## Product Change Notice (PCN)

**PCN Number:** PCN-0374184R-01

### Product(s) Affected: CEP-1162

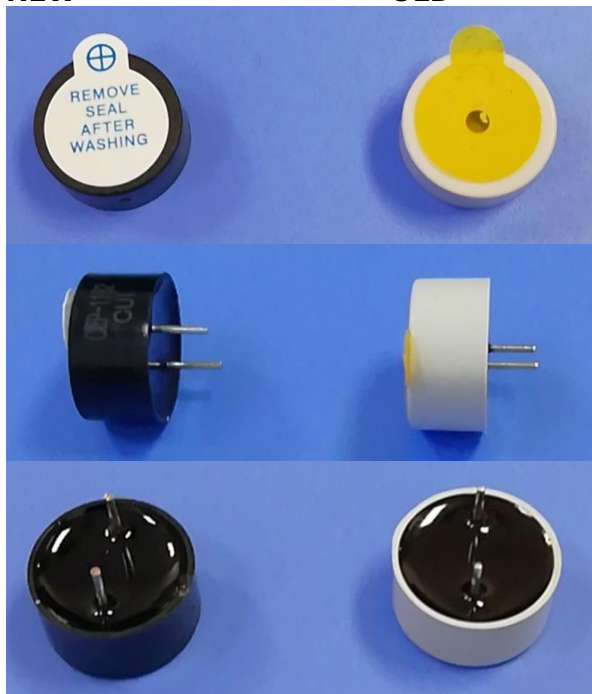
**We are upgrading the plastic housing from PBT to PBT+30% glass, and this is to achieve UL94V-0 Flame retardant level. This is a higher level than the original which was UL94V-1. The color will also be changing from grey to black.**

- Plastic change from PBT to PBT +30% Glass
- Housing color from grey to black
- Db from 80 to 85
- Operating temp now -40 ~ 85 instead of -20 ~ 85
- Storage Temp now -40 ~ 90 instead of -30 ~ 90
